**SUSQUEHANNA STEAM ELECTRIC STATION
APPLICATION FOR RENEWED OPERATING LICENSES
NUMBERS NPF-14 AND NPF-22 REQUESTS FOR ADDITIONAL
INFORMATION - LICENSE RENEWAL APPLICATION (LRA)
ENVIRONMENTAL SITE AUDIT FOLLOWUP
PLA-6248**

**Docket Nos. 50-387
and 50-388**

**Enclosure to PLA-6248
PPL Responses to NRC's
Request for Additional Information (RAI)**

Attachment 2 to PLA-6248
Non-Radiological Waste Overview

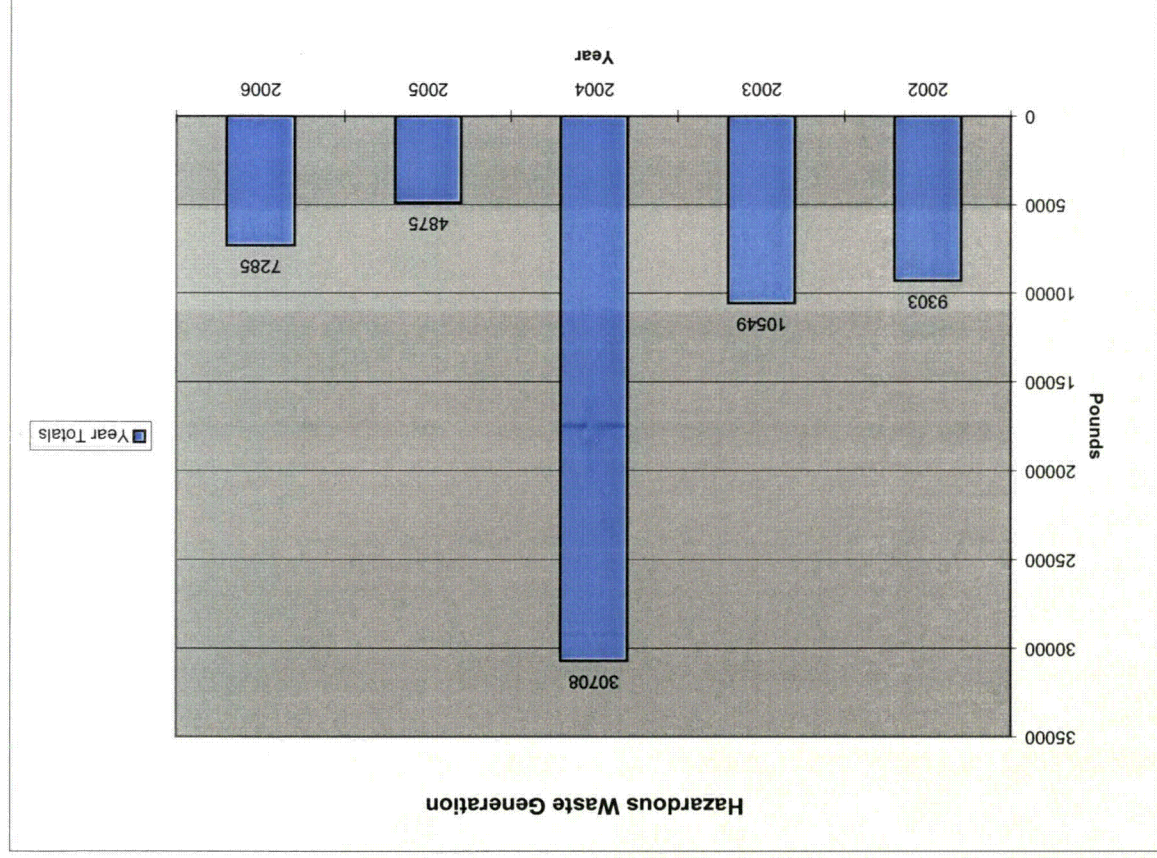
Please identify the types of non-radiological wastes (wastes classified as hazardous, universal or residual) that the SSES site has produced for each of the past five years. Please provide an accounting of waste quantities by year and waste stream. PPL

The tables in PPL Attachment #2 provide an Overview of Year and Waste Stream Totals for 1) Hazardous and Universal Wastes and 2) Residual Wastes. These wastes were generated during the past five years (2002 - 2006). Also, included are Hazardous and Residual Waste Generation graphs for years 2002 through 2006.

Attachment 3 to PLA-6248
Mixed Waste Generated

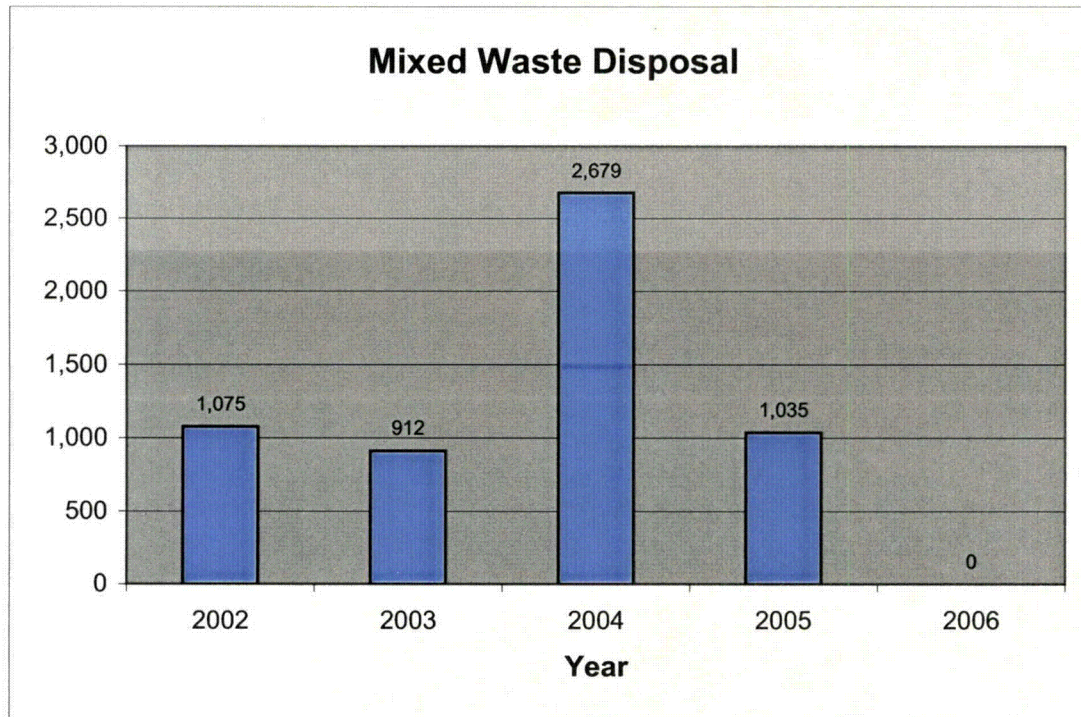
Please provide the amounts (by weight) of mixed wastes the SSES site generated over the past 5 years. PPL Susquehanna staff originally showed NRC reviewers this information at the SSES environmental site audit, as response IX Mixed Waste, D, to NRC's April 18th, 2007, environmental site audit information request.

The amount of mixed waste generated at the SSES during the last five years (2002 - 2006) is contained in PPL Attachment #3.

**Attachment 5 to PLA-6248
List of PPL Susquehanna's
Environmental Procedures**

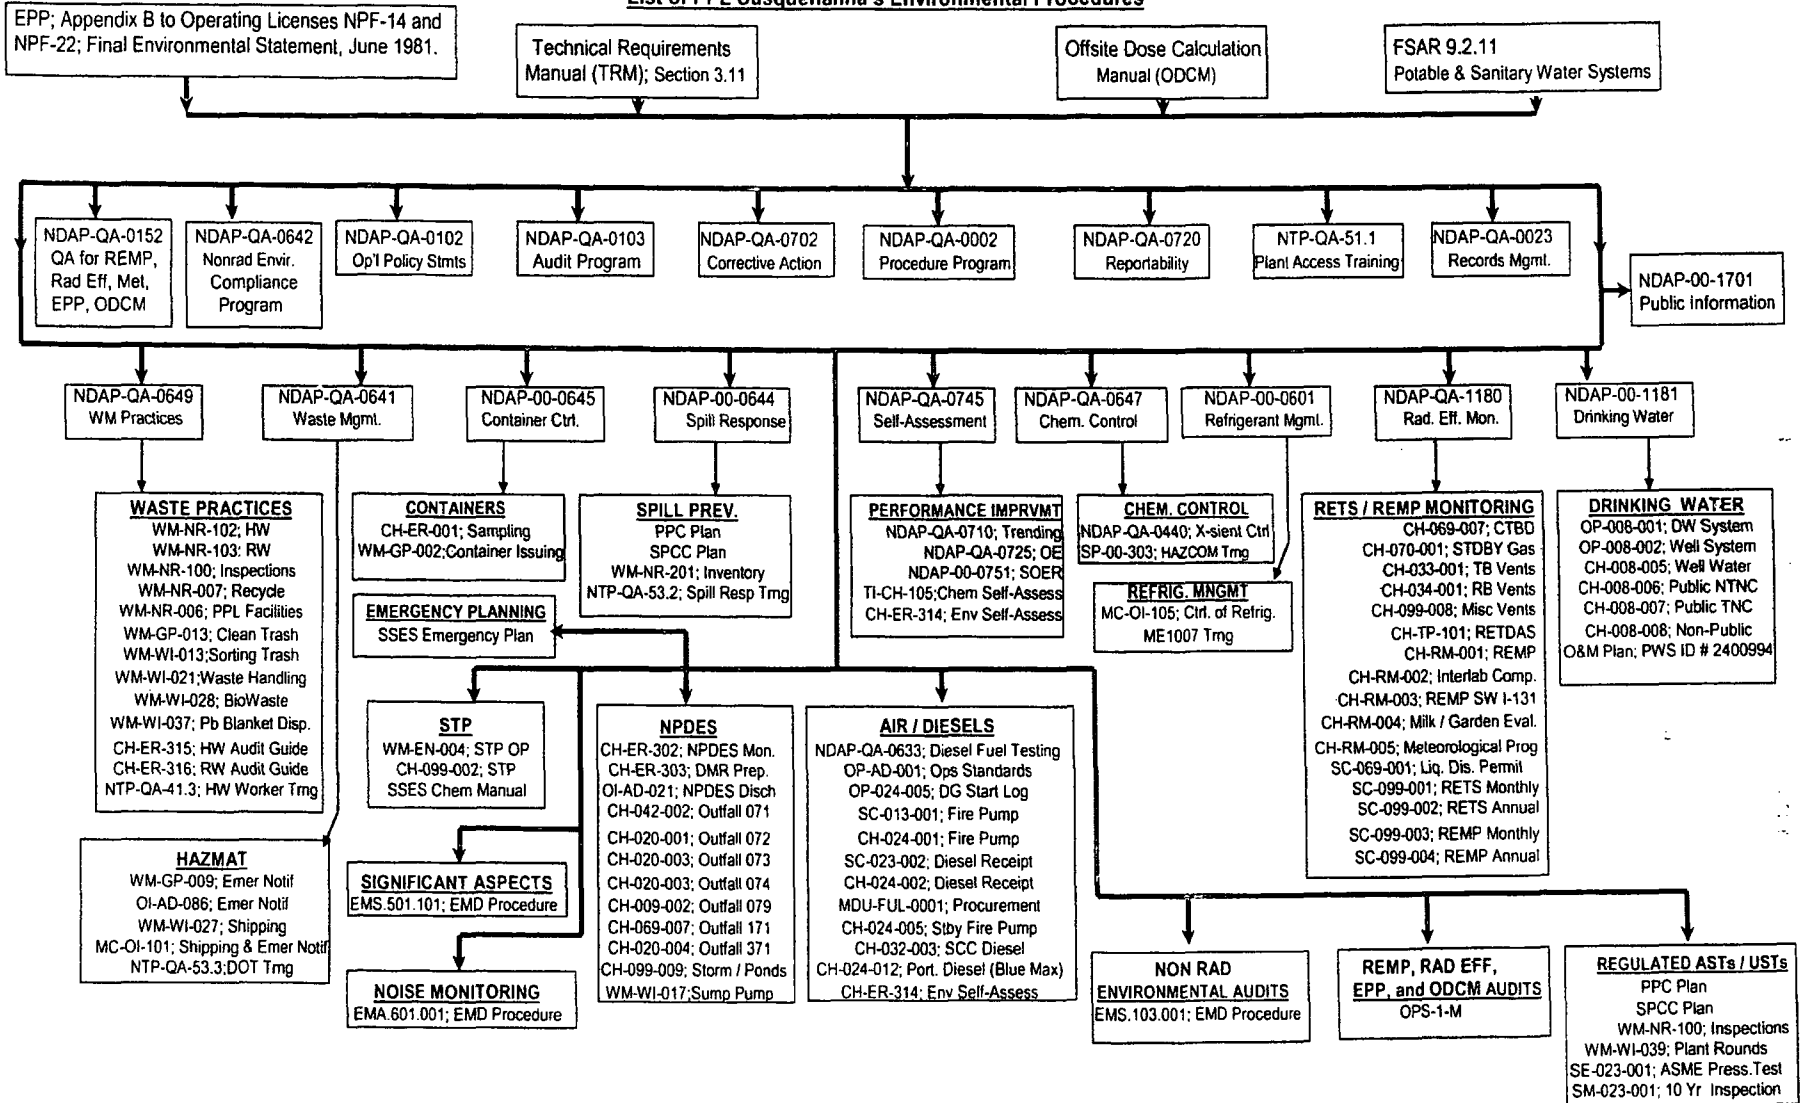
Please provide the document "Hierarchy of PPL Susquehanna's Environmental Procedures." PPL Susquehanna staff originally showed NRC reviewers this item at the SSES environmental site audit, as response VIII, Nonradiological Waste, H, to NRC's April 18th, 2007, environmental site audit information request.

PPL Attachment #5 contains the requested document.
